Village of Arlington Heights
Plan Commission
Virtual Meeting
December 2, 2020
7:30 PM

- A. Trammell Crow Senior Living - 2015-2045 S. Arlington Heights Rd. - PC#20-013
Rezoning from O-T to I District, PUD, Several Variations

To: Plan Commission
Prepared By: Sam Hubbard, Development Planner
Meeting Date: December 2, 2020
Date Prepared: November 25, 2020

5 MEMORY CARE FENCE - ELEVATION 2
A1-3 1/8" = 1'-0"

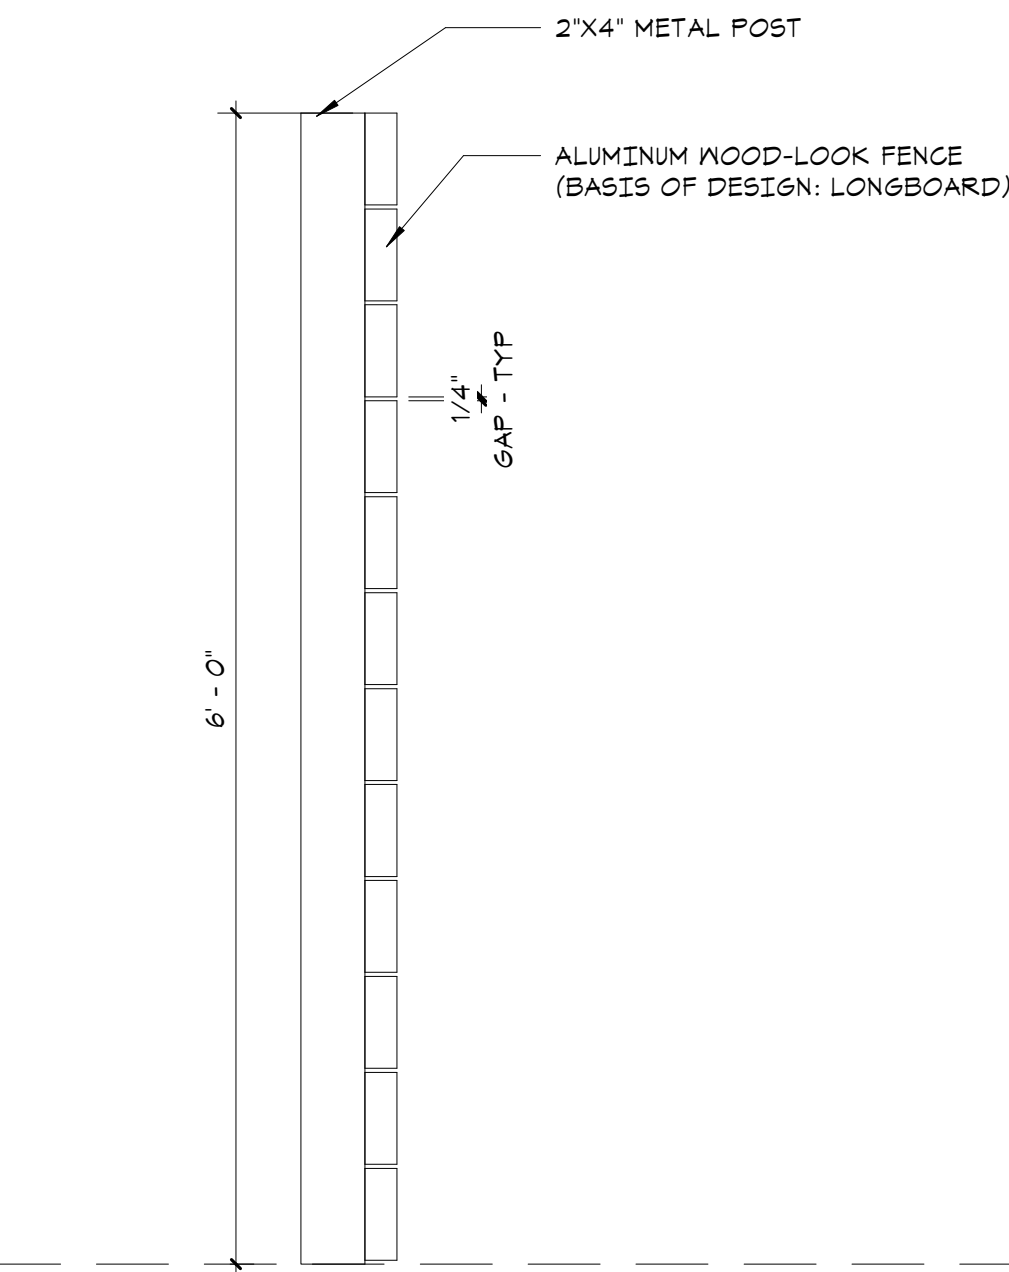
- 30) The response to comment #11 is noted. Per recent emails, a fence is also proposed along the side of the IL Terrace.
 Response: The fence alongside the IL Terrace is the same design and height as the one around the Memory Care courtyard. Please see sheet A1-3.
